January 7, 2022
Project Number: 210166-05

**Re: Addendum to Amendment to Environmental Compliance Approval No. A371203
MECP Reference #3258-C93K73**

The following is an addendum to the Environmental Compliance Approval (ECA) amendment application submitted on November 23, 2021, with supporting documentation for a further amendment to ECA No. A371203, dated March 19, 2021, and issued to Waste Management of Canada Corporation (WM) for the Richmond Landfill site (the Site) located in the Town of Greater Napanee, ON. This addendum package has been prepared in consultation with WM and is being provided on their behalf.

TITLE
SOUTH EAST PORTION
SITE PLAN

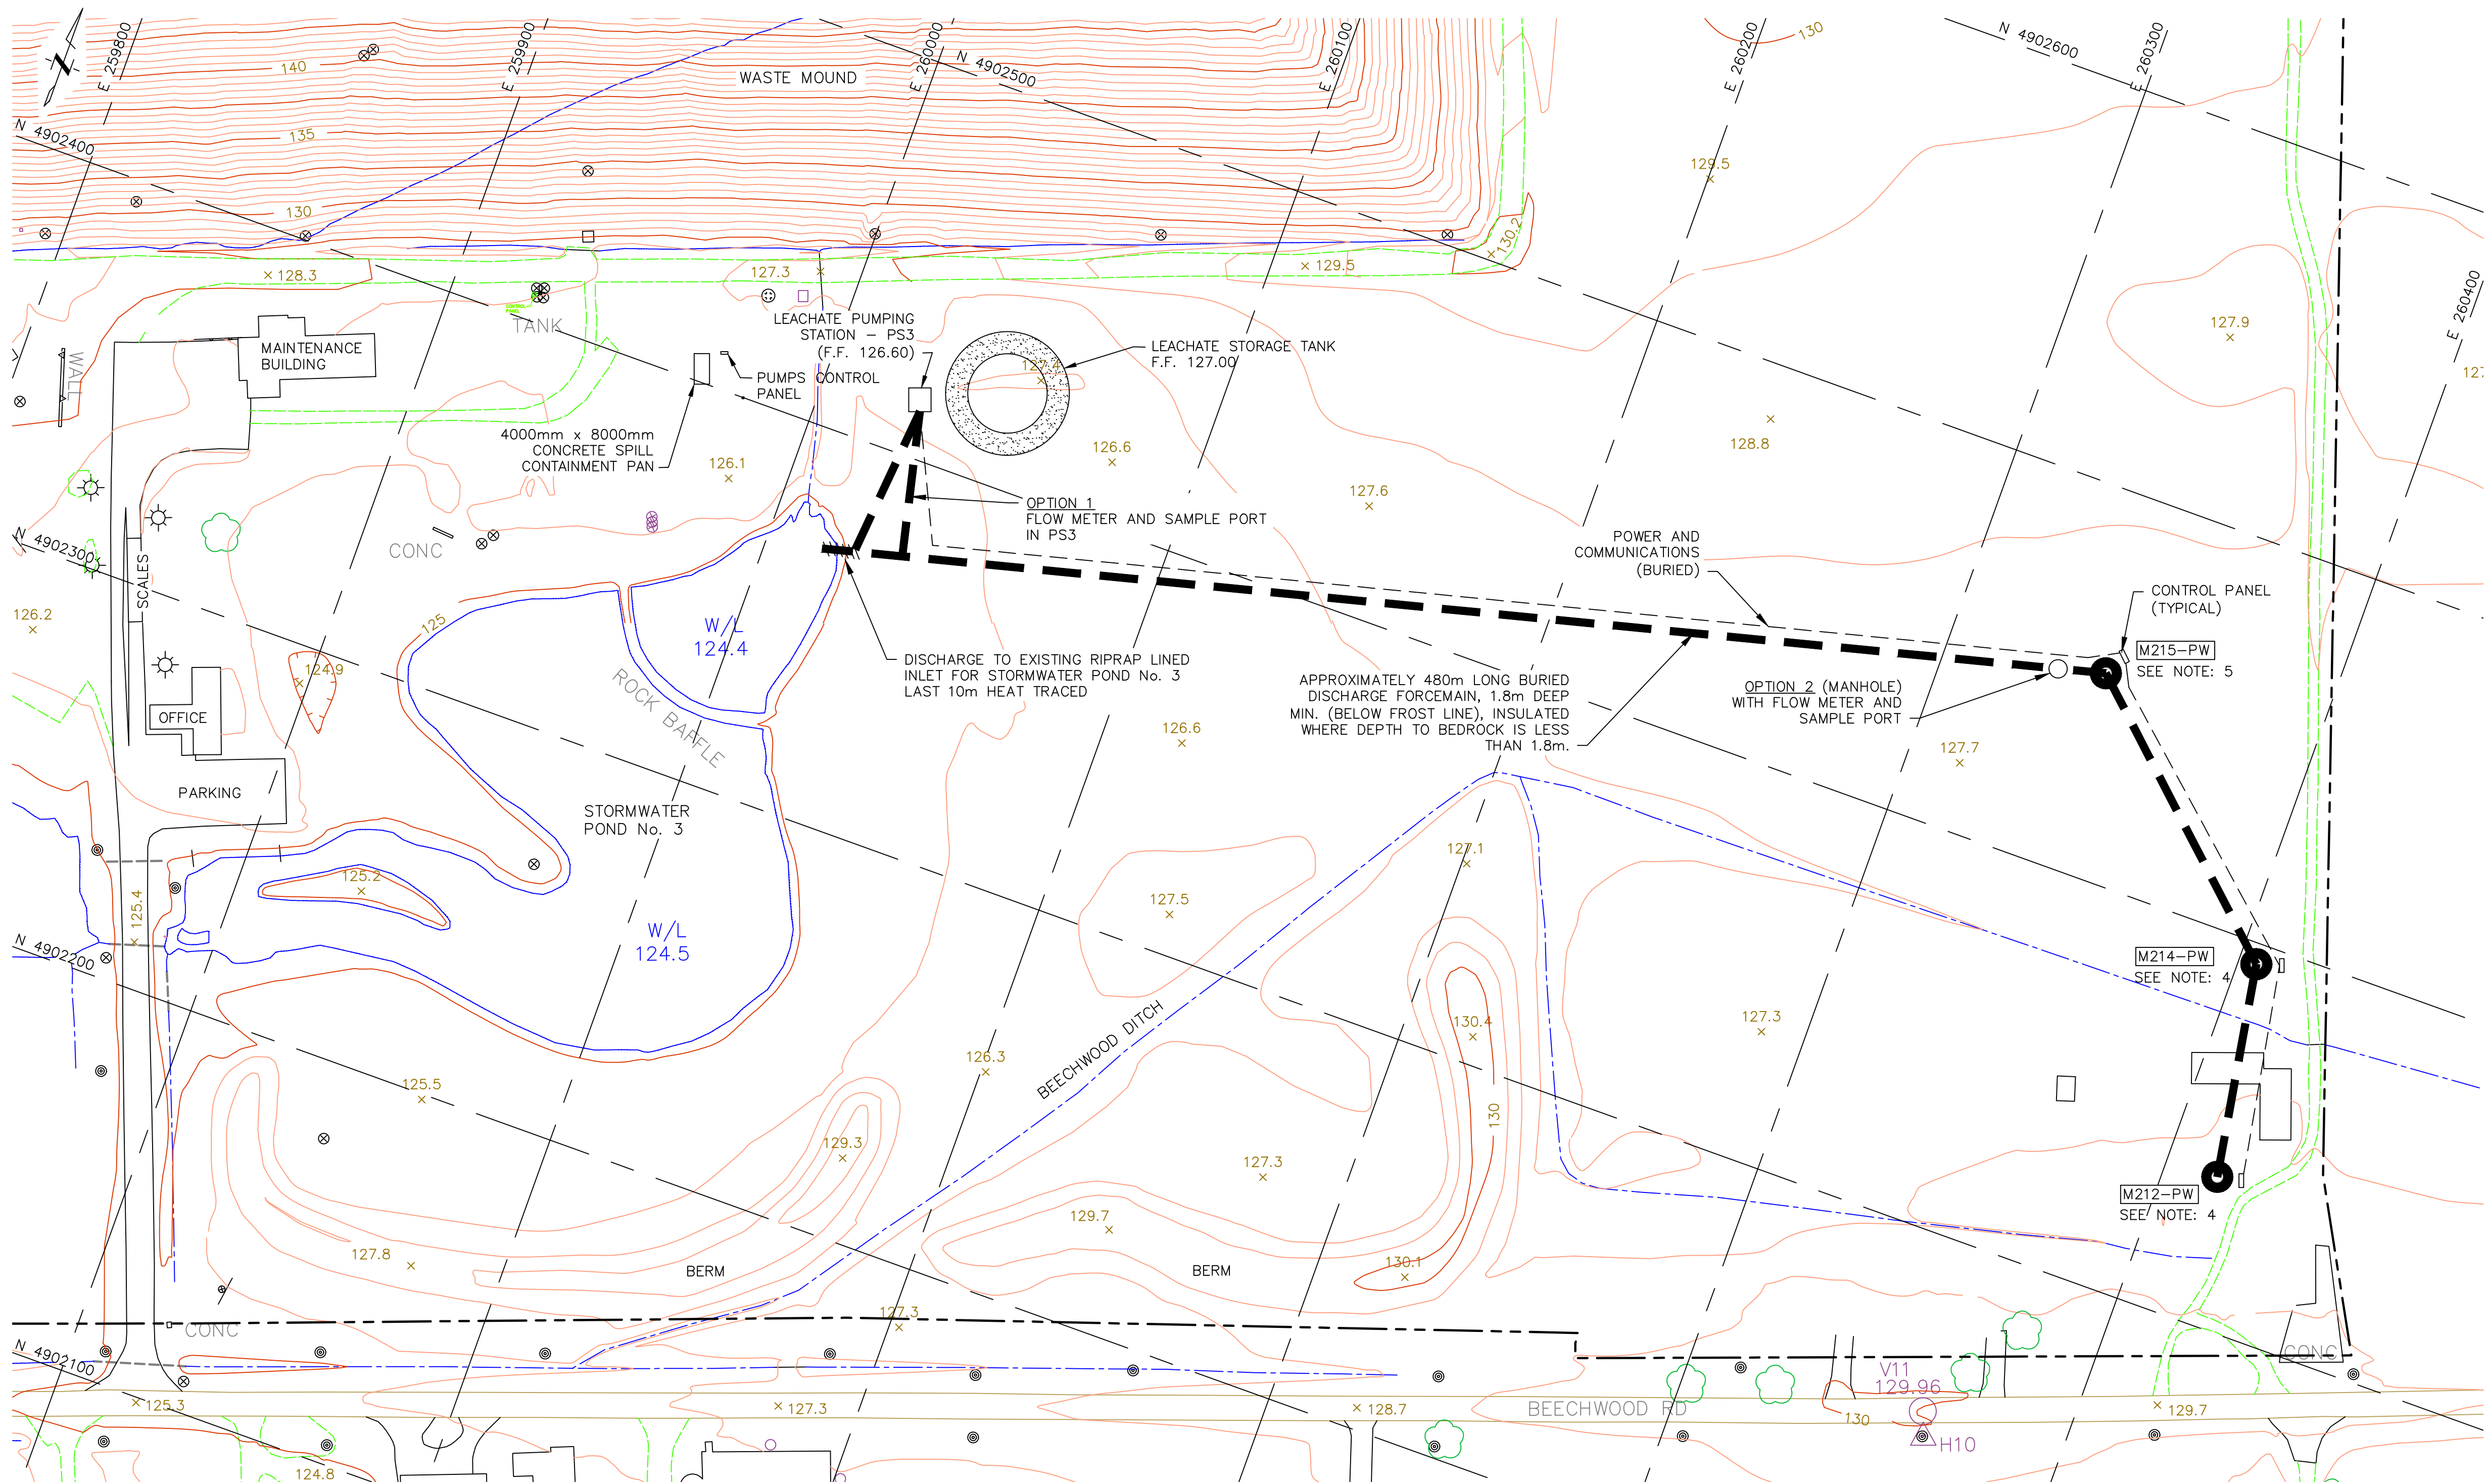
In addition to the previously requested changes, WM is requesting the addition of the HCS as follows:

ECA Section and Condition	Change Requested and Rationale
TBD	<p>Hydraulic Control System (HCS) to include:</p> <ul style="list-style-type: none">• Three groundwater extraction wells open in the intermediate bedrock flow zone;• Discharge pipe from the extraction wells to existing Stormwater Pond No. 3; and• Controls and monitoring including water levels in each extraction well and measurement of cumulative groundwater extraction rate. <p>The objective is to hydraulically control off-site migration of landfill leachate impacted groundwater in the intermediate bedrock flow zone, while minimizing the volume of extracted groundwater (as delineated from extensive hydrogeological investigations based on the extents of primary leachate indicator 1,4-dioxane).</p>

Figure 2 shows the southeast portion of the site highlighting the proposed HCS. The HCS will include the following components:

Pressure transducers and submersible groundwater extraction pumps will be installed in each of the three extraction wells to monitor the water level and control the pump discharge. Pitless adapters will be installed in the existing casing to maintain the discharge line below frost. A localized control panel at each extraction well will be installed to control the operations of the pump and transmit data to equipment that will be housed in existing Pumping Station PS3 (see **Figure 2**) for remote monitoring of the system.

A sample port and flow monitor will be installed either inside heated Pumping Station PS3 (Option 1) or downgradient of M215-PW in a maintenance hole (Option 2) (see **Figure 2**). The final location will be determined during detailed design. If the sample port and flow meter is installed in a maintenance hole, sample ports will be configured to provide access without entering the maintenance hole and the flow rates will be transmitted electronically. Heat tracing will be used to prevent freezing.
